Technical Service Bulletin: TSB240060

New Rocker Lever Cover Part Number

- 15N CM2380 104B
- 15N CM2380 105B

Figure 1, Rocker Lever Cover, Pressure Relief Valve, and Pressure Relief Valve Location.

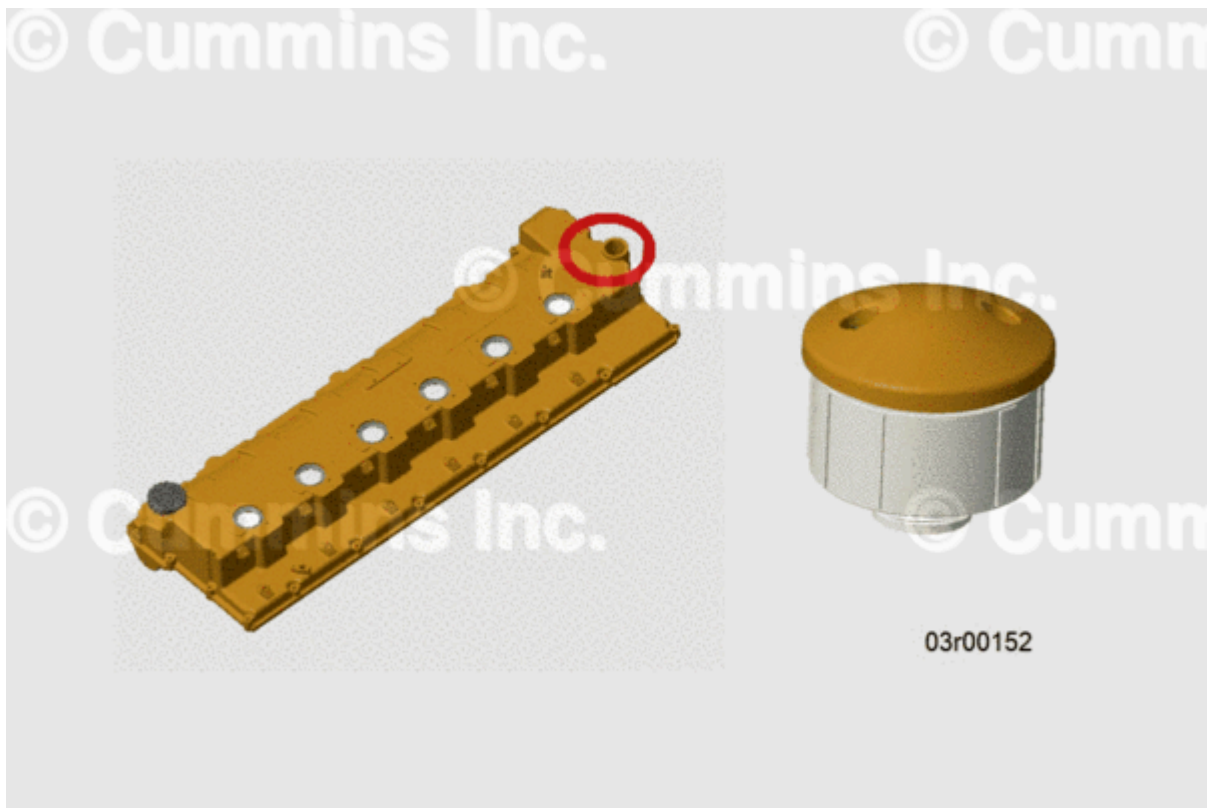
A new rocker lever cover part number has been released.

The position of the lubricating oil filler cap at the rear of the rocker lever cover is occupied by a new pressure relief valve.

If using a new rock lever cover, Part Number 6462747, a pressure relief valve, Part Number 6471803, should be ordered together.
